THE SPRINGS AT BOERNE STAGE SUBDIVISION
MASTER DEVELOPMENT PLAN - 744-B

Re: **The Springs at Boerne Stage Subdivision (Amending)** **MDP # 744-B**
Dear Mr. Cude:

The City Staff Development Review Committee has reviewed **The Springs at Boerne Stage Subdivision (MDP) Master Development Plan # 744-B**. Please find enclosed a signed copy for your files. Your plan was accepted however please note the following:

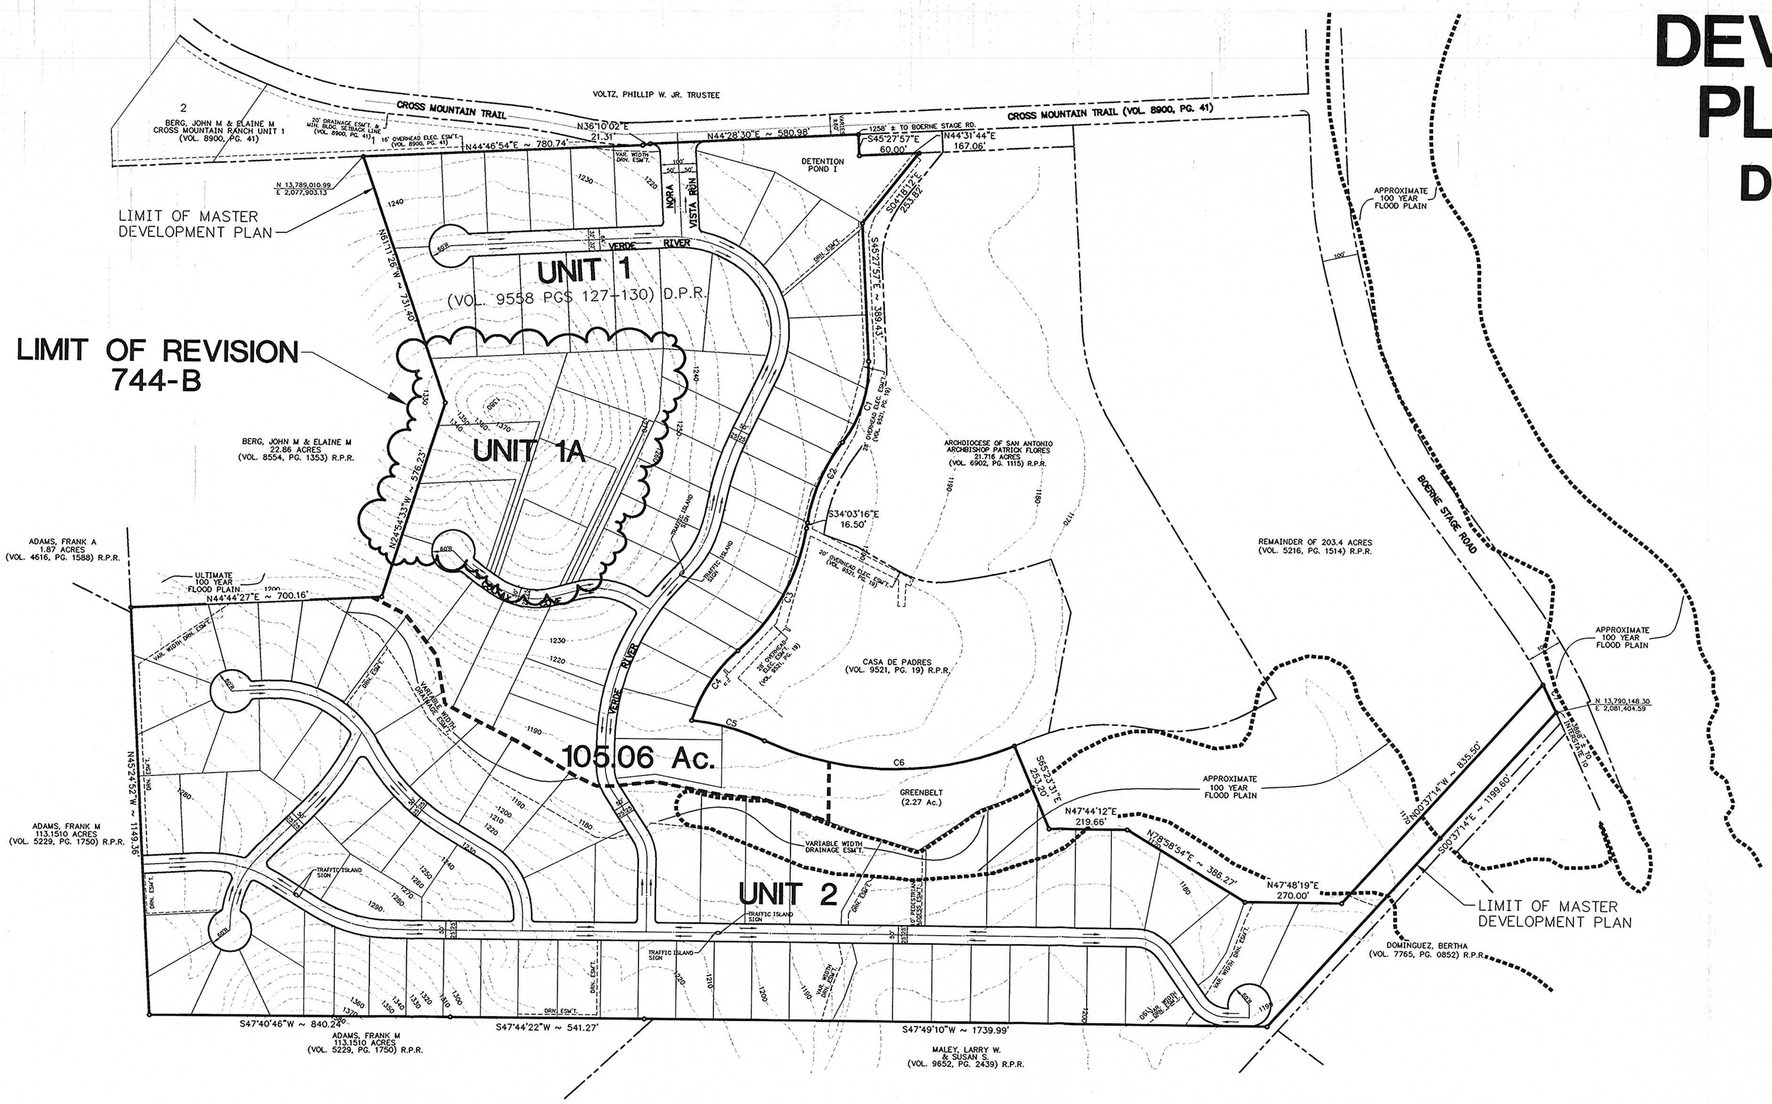
- In consideration of public safety and convenience, excessive grades by reason of topography should be avoided in street layouts and arrangements.

- Any access and R.O.W. issues along state facilities will need to be resolved with the **Texas Department of Transportation (TXDOT)**. For information about these requirements you can contact TXDOT at 615-5814.

1. It should be understood that this is a general review of a conceptual plan and that ***all*** technical requirements of the Unified Development Code for Streets & Drainage shall be complied with at the time of platting.

- This development will need to comply with the **2003 Tree Preservation ordinance.** Additional permitting fees and affidavits and preservation plans will need to obtain tree permits during the platting and /or building permit stages. For information about these requirements you can contact Tree Preservation at 207-8265.

SAWS Aquifer Protection and Evaluation will require the following pursuant to the Aquifer Protection Ordinance No. 81491, for Plat Certification.

1. 100 year Flood Plain Shown and Buffing (if applicable)
2. Sensitive Recharge Features and Buffing (if applicable)

3. Category Letter for All Site Specific Plats (if Category 2 or 3, an Aquifer Protection Plan is required)

- Additionally, a Water Pollution Abatement Plan or Contributing Zone Plan must be submitted to and approved with the Texas Commission on Environmental Quality (TCEQ) prior to construction.

According to the Water Quality Ordinance # 81491, Section 34-914, buffing is required. Approval is contingent on compliance with impervious cover restrictions in the Floodplain Buffer Zone of 6.35% as stated in a letter dated 10/2/02 describing the calculations for the buffer area in the WPAP Contributing Zone Plan by M.W. Cude Engineers, L.L.C.

- **Bexar County Public Works** has indicated as part of their conditional approval it should be understood that this MDP is a conceptual plan and all regulations will be addressed at the time of platting.

Bexar County reserves the right to address Driveways, Street Design, Sight Distance, ADA requirements, Drainage and Flood Plain issues at the time of platting.

- It will be expected that you will plat all of the property depicted in your (MDP) Master Development Plan, to include floodplains, drainage areas and open space.
